Interactive comment on “Measuring variations of $\delta^{18}\text{O}$ and $\delta^2\text{H}$ in atmospheric water vapour using laser spectroscopy: an instrument characterisation study” by F. Aemisegger et al.

Replies to the comments from referee 2

[Interactive
Comment](#)**Fig. 1.**[Full Screen / Esc](#)[Printer-friendly Version](#)[Interactive Discussion](#)[Discussion Paper](#)

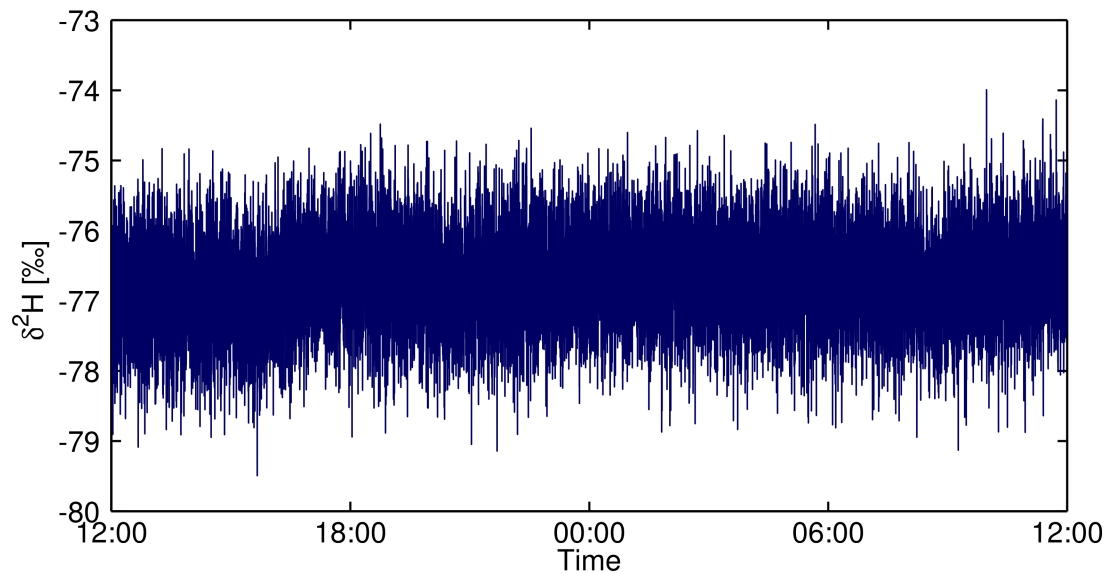
a) It would be most instructive to present the Allan plots of Figure 8 together with the time series data used for its calculation. In fact, for anybody who has generated such figures him- or herself it is evident that the shape of the curve depends, sometimes significantly, on the exact beginning and end point of the time series, as well as its exact length.

We do not think that such a plot gives much information to the reader. We performed

an Allan test and chose the stationary part of the measurements, i.e., the period when the calibration system was in steady state. We of course left out the start and the end of the calibration run to avoid any influence from the calibration unit warm up or valve switch. The goal here is to characterise the instrument precision and drift in an ideal set up. The following figure shows the $\delta^2\text{H}$ measurements by L1115-i:
